October 22, 2019

**Re: Cellco Partnership – Proposed Telecommunications Tower
764 Charlton Road - Tax map parcel No. 246.00-2-26.1**

**SUGGESTED CHECK LIST
CELLCO PARTNERSHIP APPLICATION
OCTOBER 22, 2019**

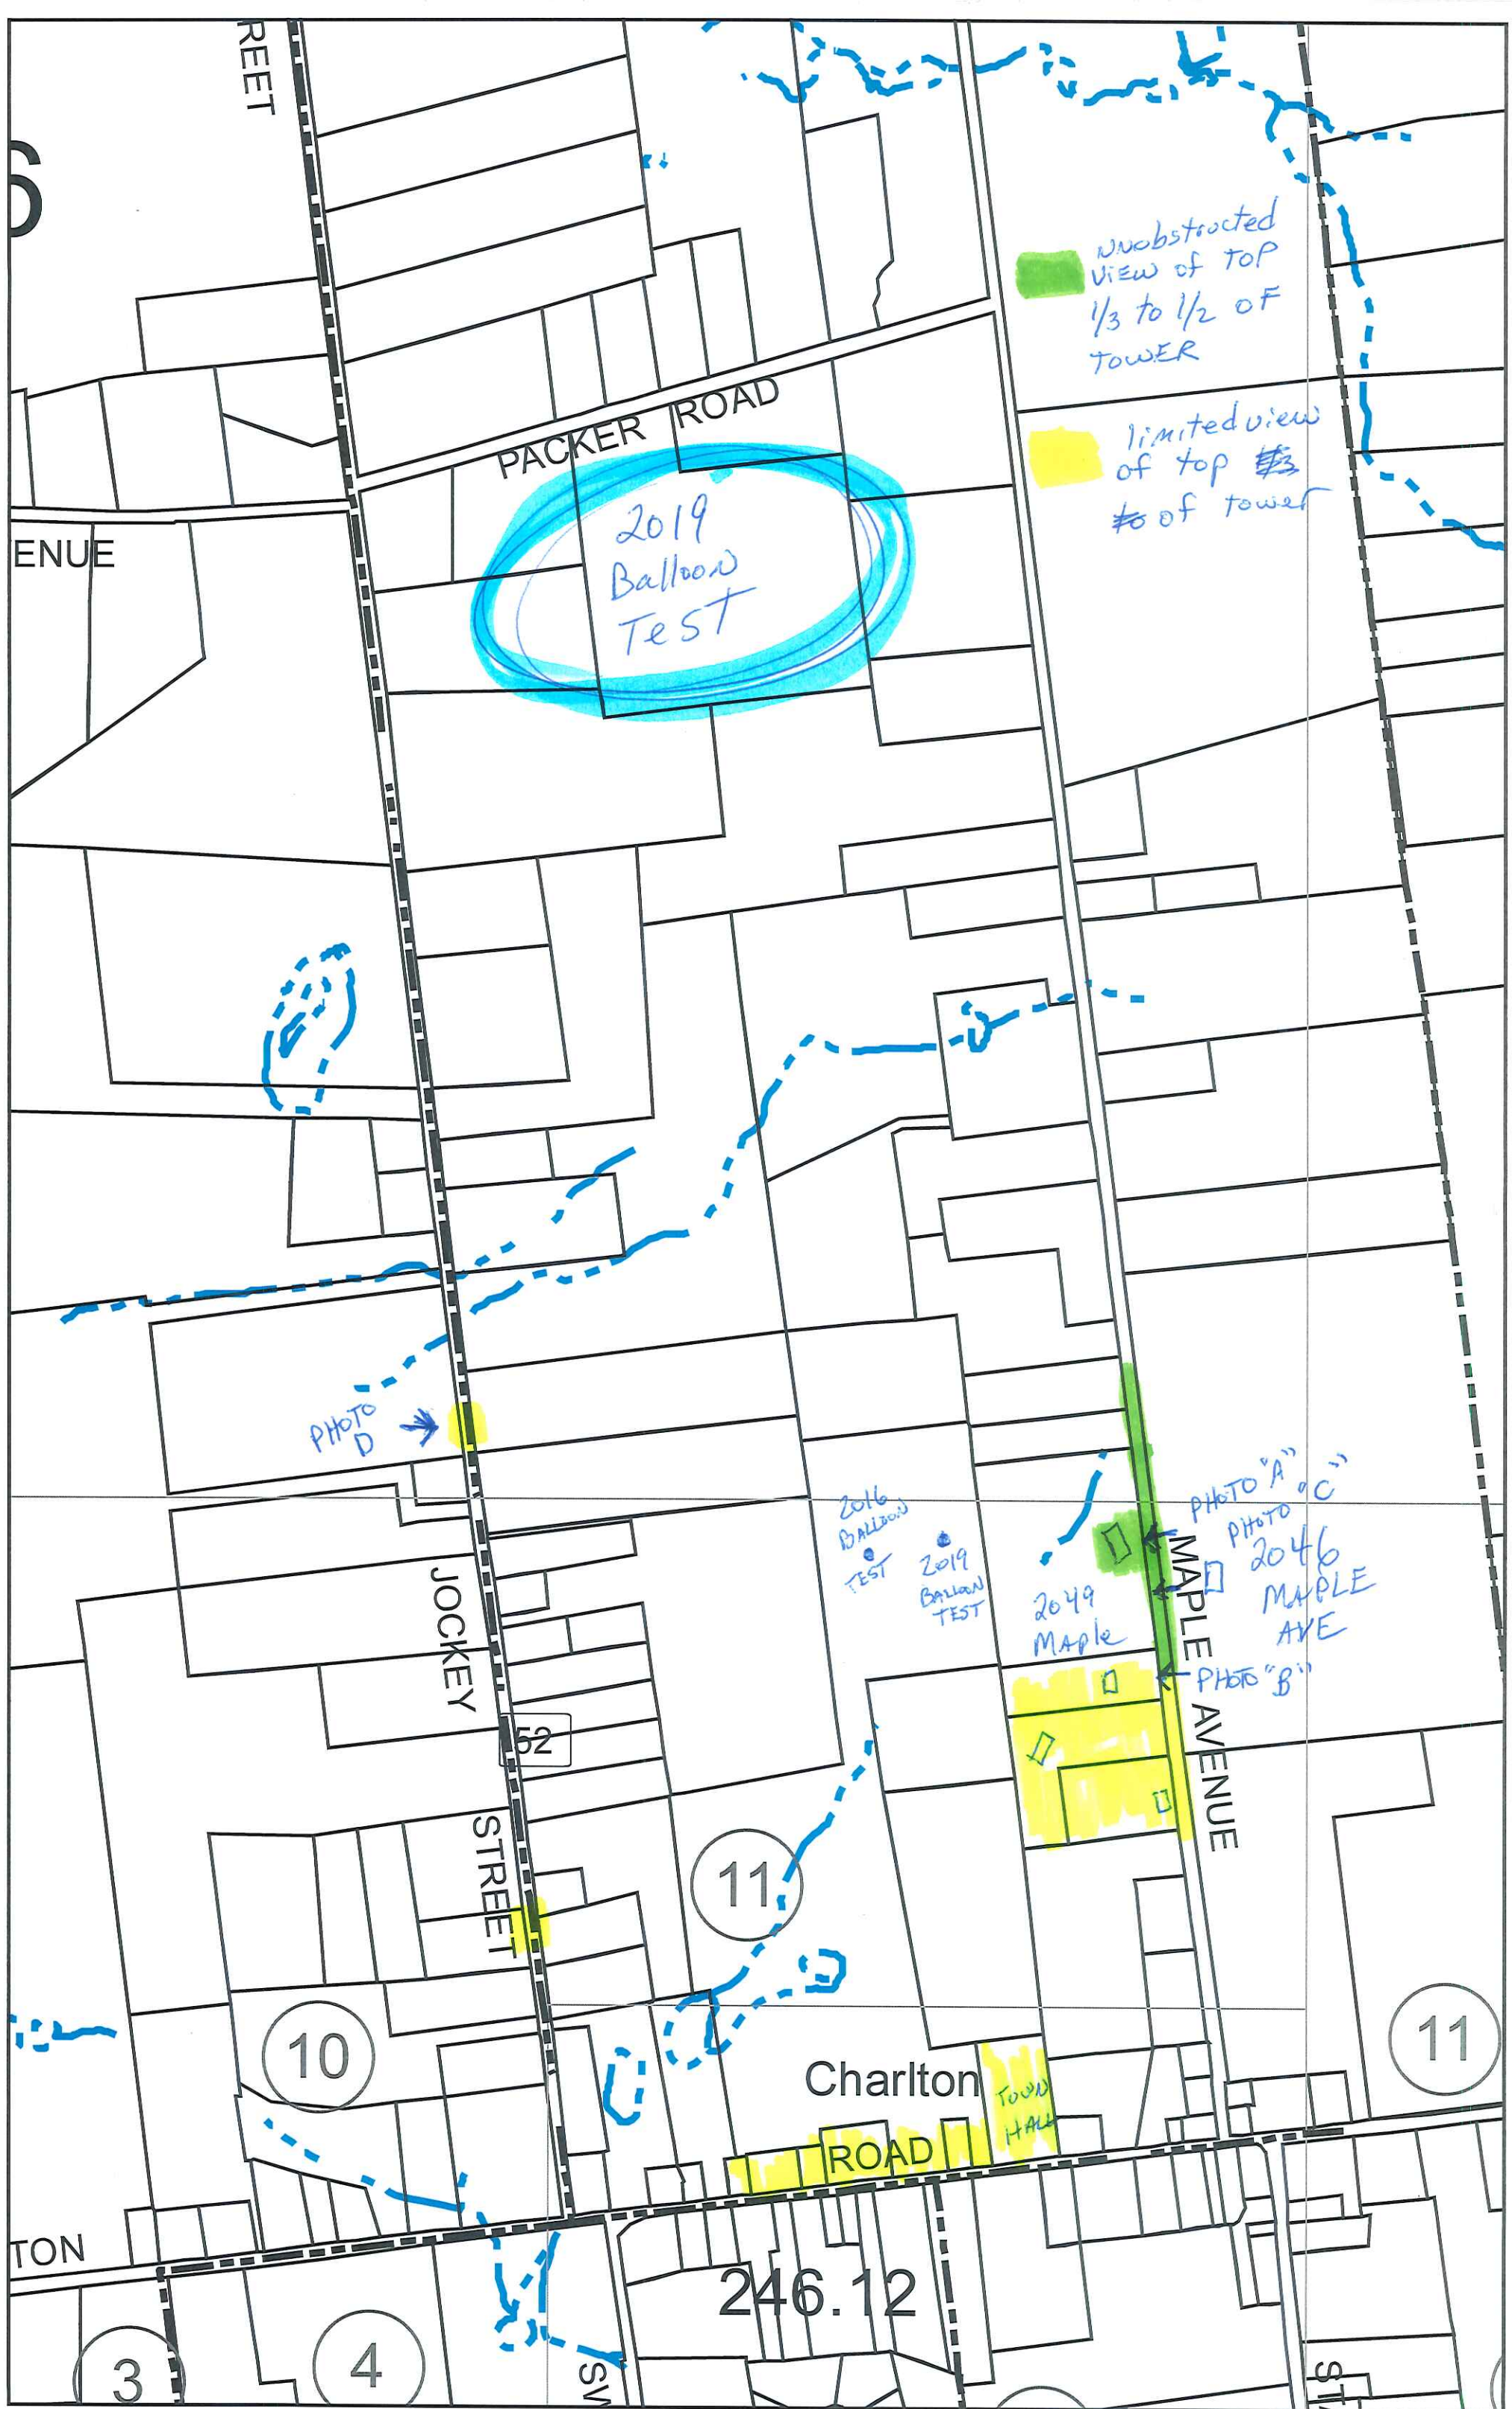
Generally, the tower is either not visible or is significantly muted by the tree lines from most areas. The tower is more than 1,000 from any roadway and does not line up with any roads so that a prolonged view for travelers would result. The tower will not be visible from the Elmer Smith Park or the Cherry Lane residential area. It is also unlikely that homes on the south side of Charlton Road will have any view of the tower. It will not be visible from the east and west ends of Charlton Road near the Maple Avenue and Jockey Street intersections respectively. The central portion of Charlton Road including the Town Hall will have a marginal visibility of the very top of the tower just above the tree line from the rear yard of those properties. (Photo #6)

Jockey Street will have very limited views of the tower. An obstructed view of the tower through the trees may be possible for a short stretch just north of the Town Garage. A clearer view of the top section will be visible about 0.6 miles north of Charlton Road. An open field on the east side of Jockey Street will allow a view of the top 20-30 feet of the tower just above the tree line. (Photo #5) This view is available for a length of only a few hundred feet on Jockey Street. The tower will not be visible at any point farther north. For the most part, Jockey Street views will be from the roadway and yards. Due to vegetation and terrain, there did not seem to be any significant views of the balloon directly from any homes along Jockey Street.

Maple Avenue will have the most direct views of the cell tower. Working north from the Charlton Road intersection, there is no visibility of the tower for the first 0.25 miles. For the next 0.15 miles, north, there is an obstructed view of the top 20-30 feet of the tower through and/or above the tree line. (Photo #4) There are three homes on the west side of Maple Avenue within that partial view zone. From about 0.4 miles to 0.6 miles north of the Charlton Road intersection, there will be a direct view of the top one third to two thirds of the tower. There are two homes within that direct view range. (Photos #1, 2 & 3)
